PROPERTY SURVEY SURVEY STATE STATE

Purpose of Report: SELF ASSESSMENT BUILDING SURVEY

Report Reference: SABS/MXP/20XX

- The purpose of the survey is to inspect the structural integrity of the conservatory roof supporting structures to determine how the conservatory will deal with any adverse weather conditions.

Fault Imagery (conservatory support beam fixing location to main building)

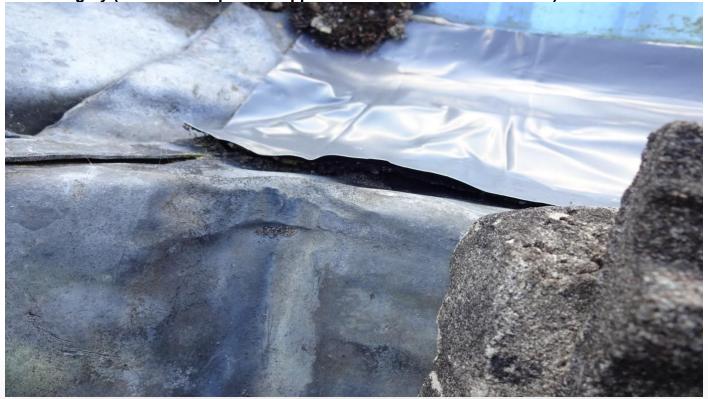
- Inspection revealed physical evidence to support that steel has been added to the sides of the beam along its full length however we cannot determine whether it is flat bar, angle iron or u channel or if the seating is adequate without a more intrusive investigation.

- I would surmise that PVCU cladding around the beam has been replaced to cover the extra width added by the steel.
- The windows however were not replaced following a decision by the contractors that the steel supports within the PVCU frames would be sufficient to support the dead weight loads of the beam and roof structures.

Fault Imagery (conservatory roof beam supporting structure)
